DOCKET 50-255 - LICENSE DPR-20 -
PALISADES PLANT - STEAM GENERATOR
REPAIR REPORT - REVISION 3 JULY 1979

Attached is Revision 3 dated July 1979 of the "Palisades Plant Steam Generator Repair Report." This Revision 3 contains responses to requests for additional information transmitted by letter dated May 16, 1979.

STEAM GENERATOR REPAIR REPORT

8.6	<u>REPLACEMENT OF STEAM GENERATOR EVAPORATOR SECTIONS</u>	8-6
8.7	<u>MAN-REM CONSIDERATIONS</u>	8-6
8.8	<u>CONCLUSIONS</u>	8-7
9.0	<u>COST BENEFIT ANALYSIS FOR THE DECONTAMINATION, STORAGE, AND DISPOSAL OF THE OLD STEAM GENERATORS CONSIDERING ALARA</u>	9-1
9.1	<u>INTRODUCTION</u>	9-1
9.2	<u>STEAM GENERATOR IN-PLACE DECONTAMINATION</u>	9-1
9.3	<u>STEAM GENERATOR STORAGE AND DISPOSAL</u>	9-2
9.3.1	LONG-TERM STEAM GENERATOR STORAGE ONSITE	9-2
9.3.2	IMMEDIATE SHIPMENT BY BARGE	9-2
9.3.3	SHORT-TERM STORAGE WHILE UNITS ARE CUT UP FOR SHIPMENT (WITHOUT DECONTAMINATION)	9-3
9.3.4	CONCLUSIONS	9-3
10.0	<u>REFERENCES</u>	10-1
	APPENDIX A - RESPONSE TO NRC QUESTIONS OF 4/17/79	A-1(a)-1 2
	APPENDIX B - RESPONSE TO NRC QUESTIONS OF 4/19/79	B-1(a)-1
	APPENDIX C - RESPONSE TO NRC QUESTIONS OF 5/16/79	C-1-1 3

Figure C-3-1

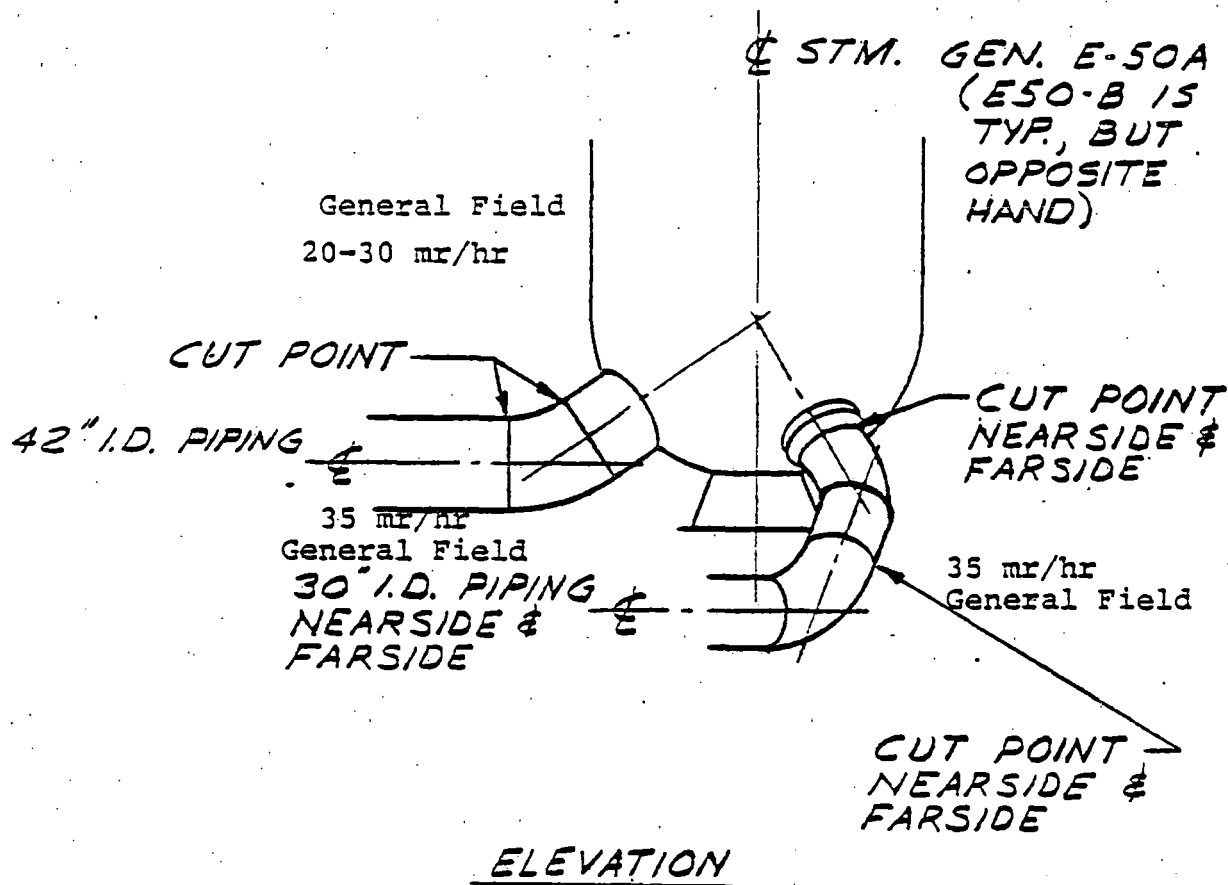
- C-3 Provide a diagram showing the radiation surveys around the steam generator replacement/repair activities. Include similar radiation surveys for Figures 4.2-4 through 4.2-7. Include a table showing the whole body dose received during the inspection and plugging of the degraded steam generator tubes for 1976, 1977, and 1978.

1. Figures 4.3-3, 4.3-4, and 4.3-5, which are included in the Steam Generator Repair Report, show radiation surveys around the steam generators at various times after shutdown. The fields specified are representative of those expected for the replacement repair activities. It should be noted that the fields specified in Figure 4.3-5 are expected to decrease significantly at the time that pipe cutting begins, considered to be 42-140 days post-shutdown for study purposes. The decrease will follow the general radiation field near the steam generator piping shown in Figure 4.3-7. Figures 4.2-4 through 4.2-7 have been modified to include general field information in areas where replacement/repair activities will occur and are now designated as Figures C-3-1 through C-3-4.
